# UNITED STATES PATENT AND TRADEMARK OFFICE

APPLICATION NO.	FILING DATE	FIRST NAMED INVENTOR	ATTORNEY DOCKET NO.	CONFIRMATION NO.
10/725,623	12/01/2003	Michael M. Kamrava	5603P001X2	4992
8791 7590 10/30/2007 BLAKELY SOKOLOFF TAYLOR & ZAFMAN 1279 OAKMEAD PARKWAY SUNNYVALE, CA 94085-4040			EXAMINER NGUYEN, CAMTU TRAN	
			ART UNIT 3772	PAPER NUMBER
			MAIL DATE 10/30/2007	DELIVERY MODE PAPER

## **DETAILED ACTION**

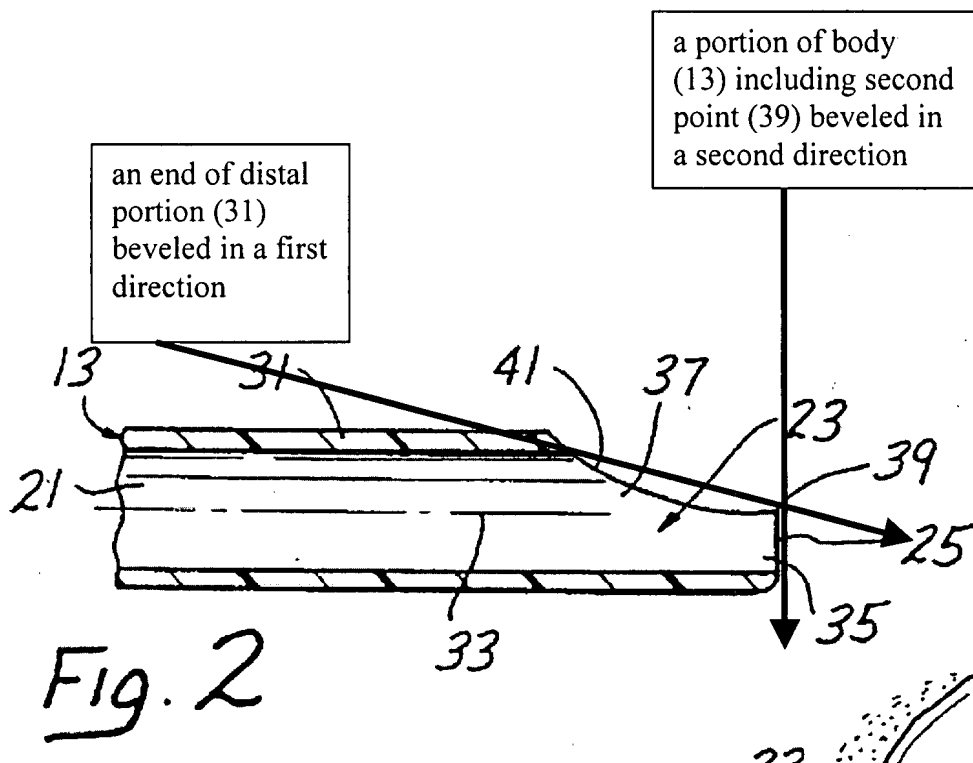
Claims 1-18 are rejected under 35 U.S.C. 103(a) as being unpatentable over by (U.S. Patent No. 4,474,576) and further in view of Bacich (U.S. Patent No. 5472419). Gobby discloses an artificial insemination a delivery member (30) comprising a delivery section (51), a storage section (53), and a passage through both sections (51, 53), the delivery member (30) defines a first axis of symmetry throughout the passage. Figure 2 illustrating a distal portion of the delivery member (30) is offset so as to preferably between 2 to 5 degrees inclined to the longitudinal axis of the delivery member (30), thus, the distal portion of the distal delivery section (31) defines a second different axis of symmetry throughout the passage a first axis of symmetry. The Gobby device does not disclose the distal passage portion of the delivery section (51) is beveled. Bacich discloses a transfer catheter body (13) comprising a proximal portion (27), a distal portion (31), an elongated passage (21), the distal portion (31) having an end that is beveled in a first direction across the passage (21), a portion of catheter (13) including a second point (39) is beveled in a second direction. Therefore, it would have been obvious to one skilled in the art during the time of this invention to modify the Gobby's distal passage portion of the delivery section (51) such that it would beveled, taught by Bacich, as such would not only facilitate the delivery process but also serve as a tool cutting through the endometrial lining when delivering the productive material.

Regarding claims 2 & 3 and 14 & 15, particularly to claims 3 & 15 reciting the beveled opening angled between 10° to 15°, Figure 2 illustrates such opening angle range.
